Service Bulletin

Subject: Revised Front License Plate Bracket Installation Instructions

Models: 2014 Cadillac CTS Sedan
with Front License Plate Mounting Package (RPO VK3)

This PI was superseded to update directions to mount the bracket. Please discard PIC5922.

Revised License Plate Bracket Installation Instructions

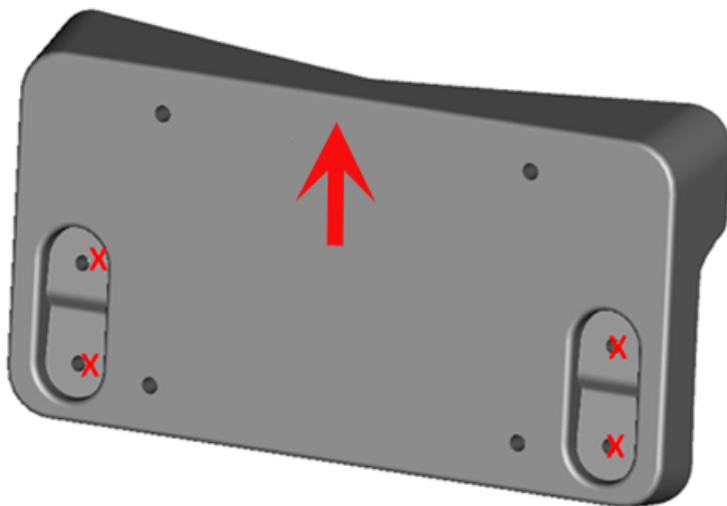
The installation of the front license plate bracket (if equipped) has been revised for better retention. Do NOT use the rivets included in the trunk bag for installing the Front License Plate Mounting Package (RPO VK3). If bolts and u-nuts are included in the trunk (small package with instruction sheet), use those to install the bracket following the instructions below. If bolts and u-nuts are not in the trunk, order four (4) bolts and four (4) nuts to install the front bracket. Reference Parts Information section below.

Note: The license plate bracket **MUST** be mounted as shown above so that airflow through the fascia is not restricted and proper engine cooling occurs.

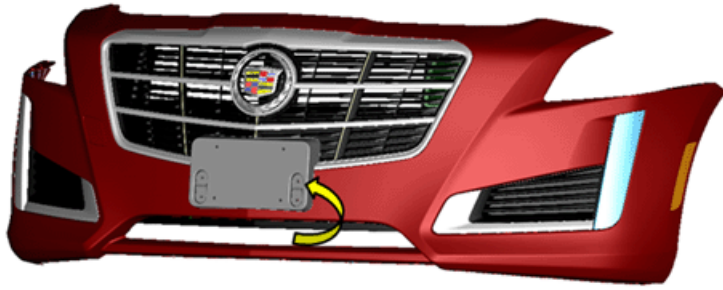
1. Drill 5.0 mm holes in all 4 location holes in bracket marked "X."

2. Install bolts through the license plate bracket and fascia holes.

3. Reach inside and behind the fascia (through the lower fascia opening) and install u-nuts on the backside. The u-nut is being used only as a nut, it does not clip on to any body parts.
4. Tighten bolts into u-nuts with a torque of (22 in lbs.) or (2.5 nm.).
